From: Sarah Featherstone [REDACTED]
Sent: 27 September 2019 10:04
To: Anita Gardner <Anita.Gardner@arun.gov.uk>
Cc: Martyn White <Martyn.White@arun.gov.uk>
Subject: Thatch Cottage applications CM/42/19/PL and CM/43/19/L

Thatch Cottage:

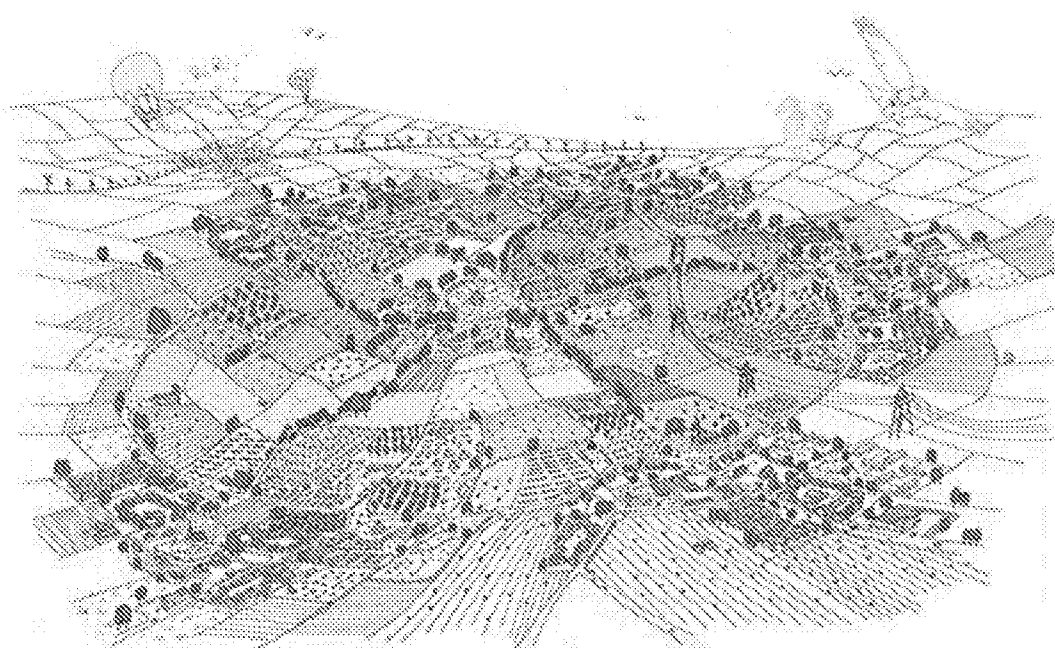
- We confirm all windows have shutters.
- No wall to edge of southern terrace, there is brick faced side to ramp where it is above grassed ground.
- Private garden - this is not enclosed but Thatch Cottage terraced area opens on to it so we envisage it being used primarily by Thatch Cottage occupants. It will be grassed so we did not think a landscape scheme would be required. Please confirm.
- MW states that the repair and replacement of thatch roof will be acceptable if it reflects those on the existing roof. We can confirm we submitted a Thatch Methodology Statement with the application which confirms the replacement thatch will match what is there on the existing roof. Please confirm no further information is required.
-
- **2. Additional details which we can issue next week:**
- T&G board detail used on external wall cladding of new extension

- Shutter details: Window 9 - proposed storm window - we stated "looks better if openings flush with window frame" — MW states "this is matter of detail" . We will provide a detail. Windows 3 & 4 - we understand MW not clear how the shutters operate - they slide in front of external wall. We will provide detail.
- Detail of stone paving specification on external terrace.
- Simple landscape of external garden if required, see note above.
-
- **3. Samples:**
- the side of south terrace ramp is shown faced in brick where it is above grassed ground. The brick will match existing brick quoins. Is it necessary to make up a sample panel for such a small area it is flush to ground at one end and rises above ground to a max height of 300mm at other end?
